P5026A-04

Information Only Service Note

P5026A Keysight Streamline USB Vector Network Analyzer

False alarm on self-test failure on firmware revision of A.13.40.02 - DDR3 memory removal

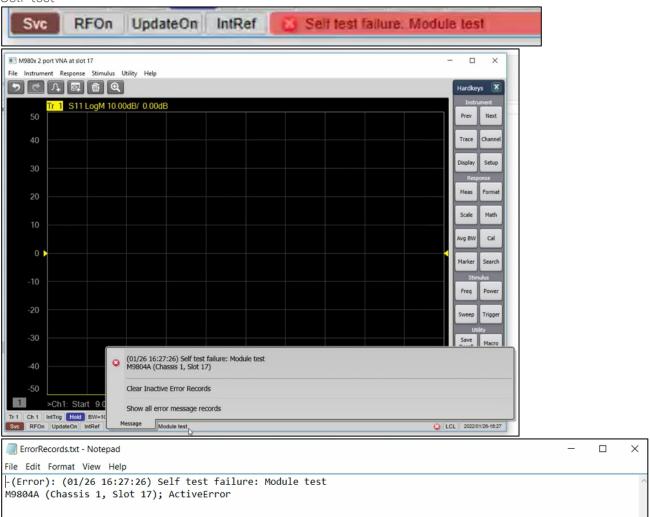
The on board DDR 3 memory in VNA is not in use since its release. With the removal of DDR 3 memory IC on newer P502xA VNA, right after firmware is launched, false alarm (self-test failure) will be reported as shown. This has no impact to VNA performance and specifications.

Similarly, firmware will report a false failure in Operator check. Shown are the error messages example on VNA firmware UI.

Since this DDR3 memory is not in use, newer firmware revision no longer consider it as the failure. Keysight recommends keeping VNA firmware up-to-date whenever it is possible.

For users with firmware revision of A.13.40.02, Update firmware to revision A.13.70.02 or newer to resolve this false alarm on self-test.
